**AERONAUTICAL CHARTING FORUM**  
**Instrument Procedures Group**  
**April 28, 2009**  
**HISTORY RECORD**

**FAA Control # 09-01-284**

**Subject: Question of TERPs Containment With Late Intercepts**

(Direct to JOCP1)

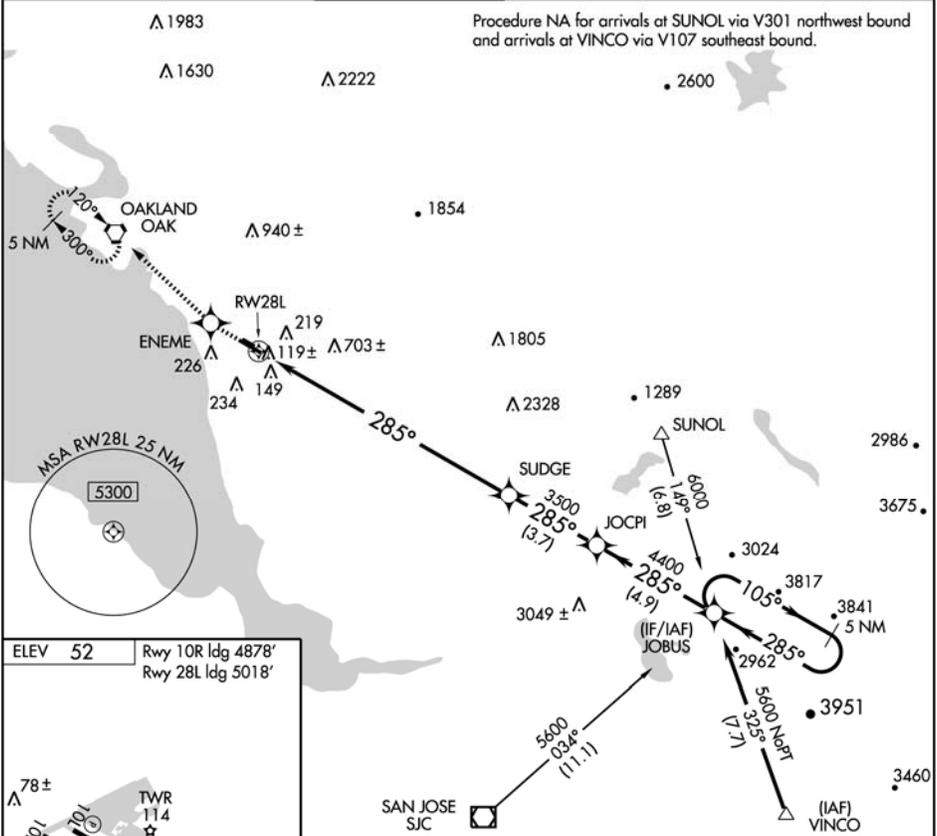
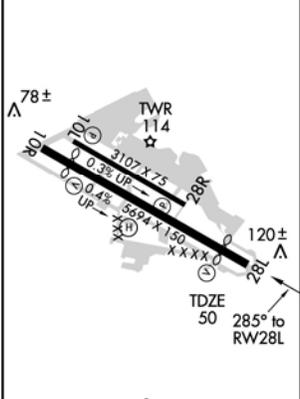
Nonetheless, within the past few years, the FAA and industry agreed after careful consideration that ATC would be permitted to clear aircraft direct to RNAV IFs, with certain strict restrictions as to controller radar monitoring, distance, angle, and altitude compatibility. During these discussions it was also agreed that controllers **could not** clear aircraft to RNAV fixes inside the IF because of issues of narrowing containment areas, aircraft maneuvering issues, and RNAV equipment sequencing issues.

There still remains the question about whether radar-monitored direct clearances to the IF are legal under the present FAA regulatory framework. 14 CFR, Part 91.175 (i) does not address substituting radar vectors with radar monitoring of a pilot’s improvisation of an ad hoc, extra-criteria initial approach segment. Further, there are no official legal interpretations which state that ATC radar monitoring of ad hoc pilot navigation to an IF is the legal equivalent of a radar vector. This legal issue is beyond the purview of the ACF. But, the safety and pilot/system performance issues and limitations are clearly within the purview of the ACF.

Recently, the Air Traffic Organization (ATO) of the FAA has decreed that ATC radar monitoring of pilot ad hoc navigation to any fix inside of the IF, up to and including the FAF, is the legal equivalent of a radar vector. Whether ATO has the authority to make such an interpretation is beyond the purview of the ACF. But, the safety and pilot/system performance issues and limitations are clearly within the purview of the ACF, and these safety issues become increasingly critical for fixes inside the IF
